Product Change Notification

PCN #: 7A-2020

Laird Part Number	Description
453-00020C	Bluetooth v5 PA Module – Integrated Antenna (Cut Tape)
453-00020R	Bluetooth v5 PA Module – Integrated Antenna (Tape / Reel)
453-00021C	Bluetooth v5 PA Module – External Antenna (Cut Tape)
453-00021R	Bluetooth v5 PA Module – External Antenna (Tape / Reel)
455-00022	DVK for 453-00020 Module
455-00023	DVK for 453-00021 Module

Label / top view before PCN change

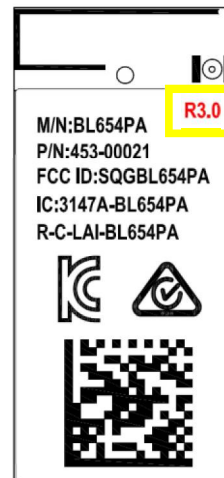
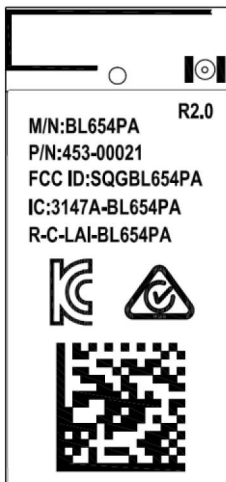
The product label, for each module variant, has been amended to show a revision change from R2.0 to R3.0, as highlighted in images below.
